Field Safety Notice Reference: FFID ECN_003504.

URGENT: FIELD SAFETY NOTICE

FUJIFILM DR-XD1000(FDR Nano) Countermeasure to strengthen the arm

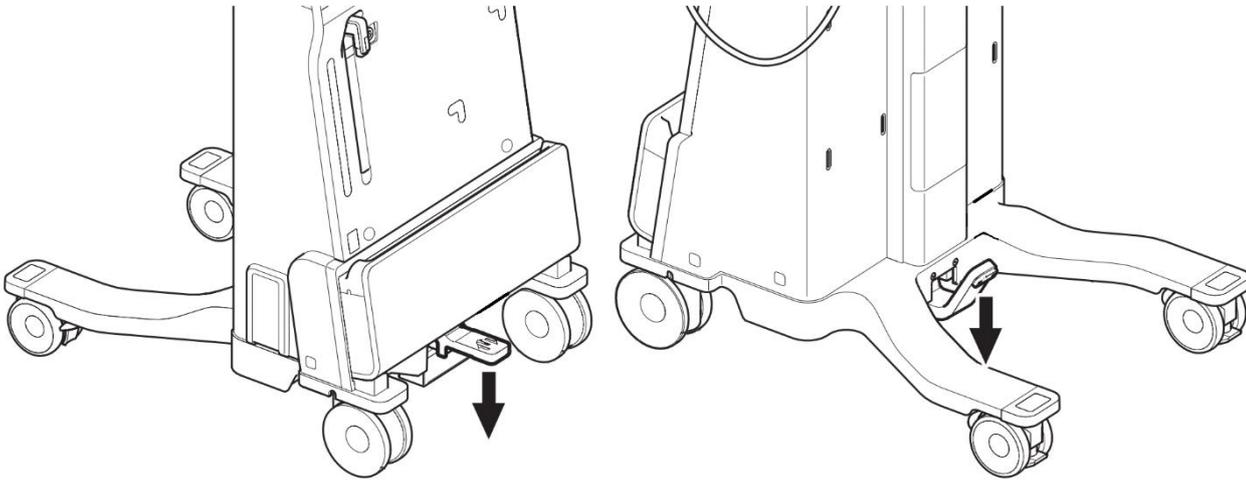
1. Set the caster lock pedal position to [Down] and secure the X-ray cart.

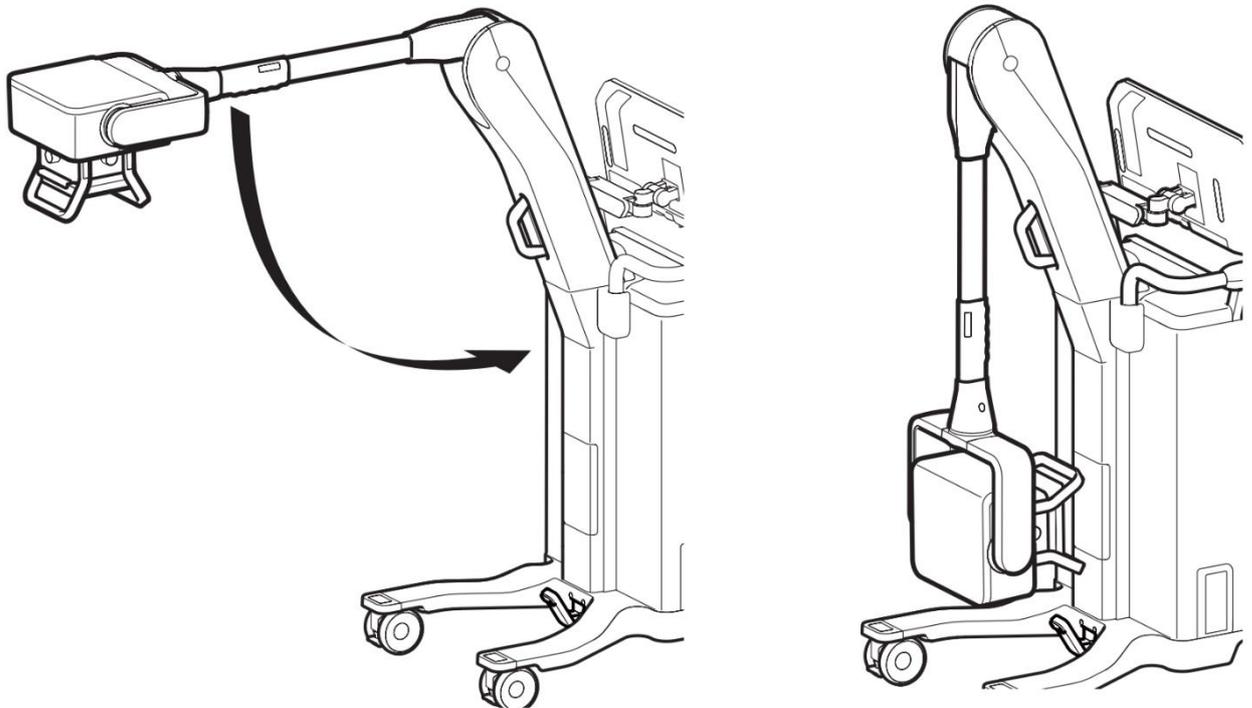
2. Store the arm in the home position.

3. Push the head arm from the side and check the following from the front.
If there is any abnormality, please stop using it and contact the contact information listed on page 1.
 - (1) Make sure that the gap between the seams of the resin cover does not widen.
 - (2) Make sure that the arm does not tilt against the resin cover.
